Rev B This document supersedes previous versions
Dec 5, 2014 Changed 046562 to include tie wrap and exhaust gasket.

UREA DOSING SYSTEM UPDATE Prevost vehicles

On the vehicles affected by this bulletin, perform a software update of EMS and ACM to modify the dosing strategy. The software will also improve urea dosing valve behavior at shutdown and key-on.

SP14-320B

Figure 9

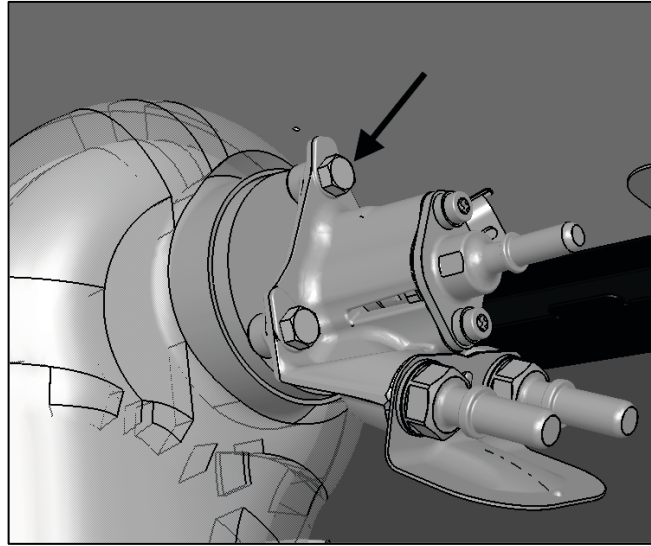
12. Remove the three bolts on the urea dosing valve.

13. Install new Urea Dosing valve **22391563** supplied with kit.

14. Tighten bolts to 7.5 lbf-ft

Figure 14 Support Layout for Vehicles From B-5064 up to C-5259 incl.

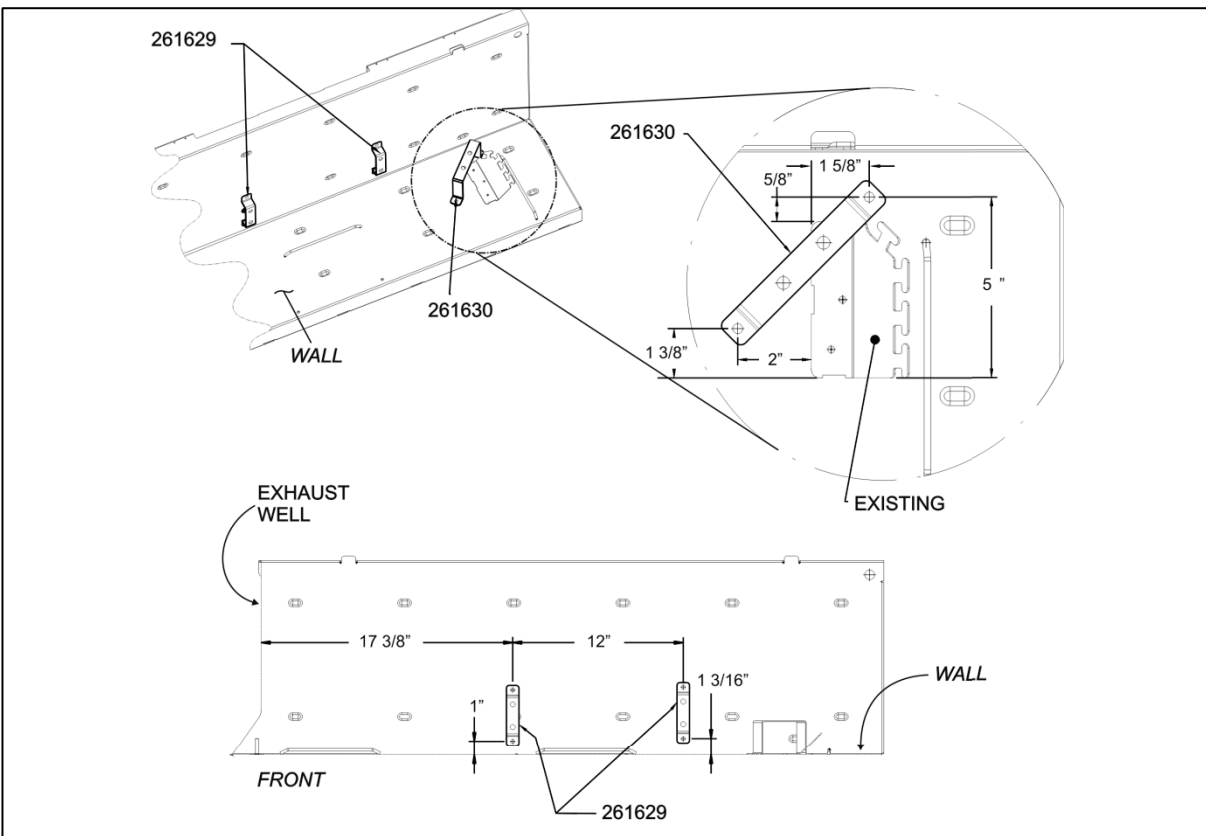
18. Mark drilling pattern for **261629** and **261630**, using brackets for hole pattern.
19. For **261629**, as a reference for measures, use wall and exhaust well edge (above exhaust bellows section) (Fig 14 or 15)
20. Vehicles from **B-5064** up to **C-5259** included require two **261629** brackets, (Fig. 14, 17)
21. Vehicles after **C-5260** included require one **261629** bracket, (Fig 15, 17).

26. Route hoses according to figure 14. *Do not tighten cable ties to allow adjustments.*
27. Adjust the length of the hoses to dimensions in fig 17.
28. Tighten all cable ties

Figure 17

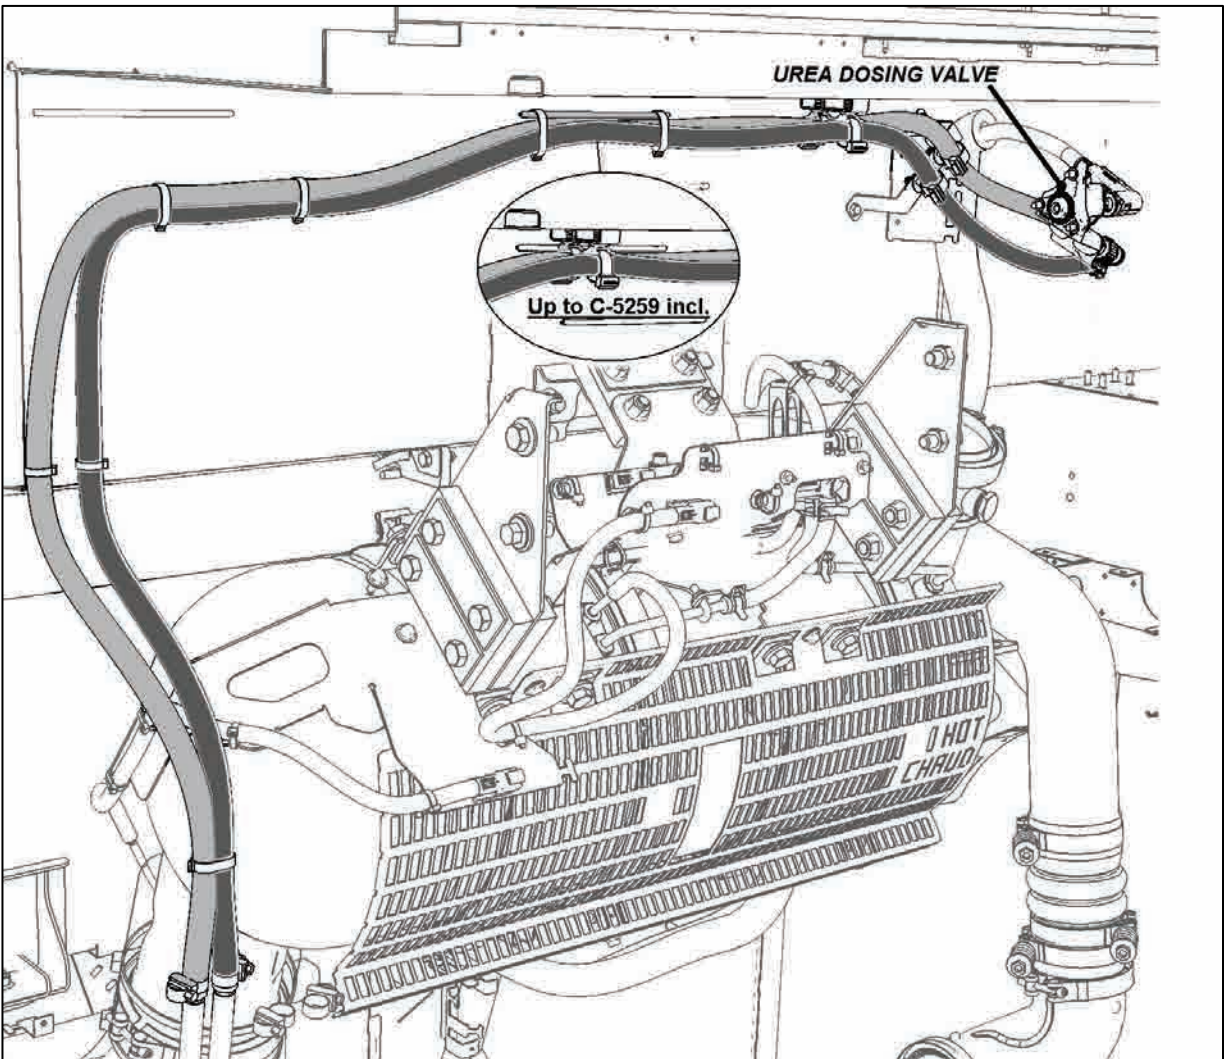
25. Assemble coolant hoses with fir tree push mount cable ties (fig. 15). *Do not tighten cable ties.*

Figure 19

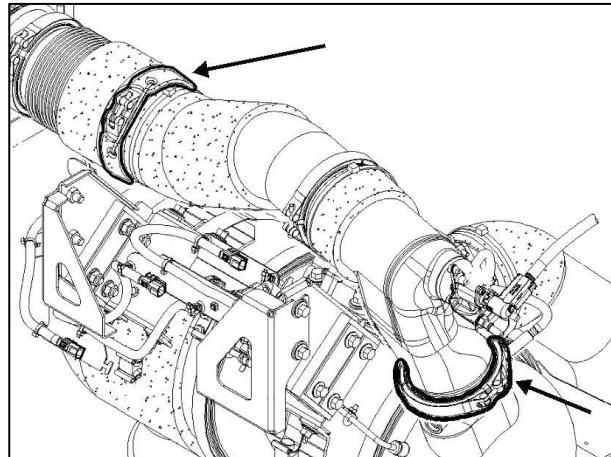
- 29. Re-assemble pipe assembly.
Tighten V-clamps to **8 lbf-ft**
Change V-Clamp gasket #**21095721** if required.
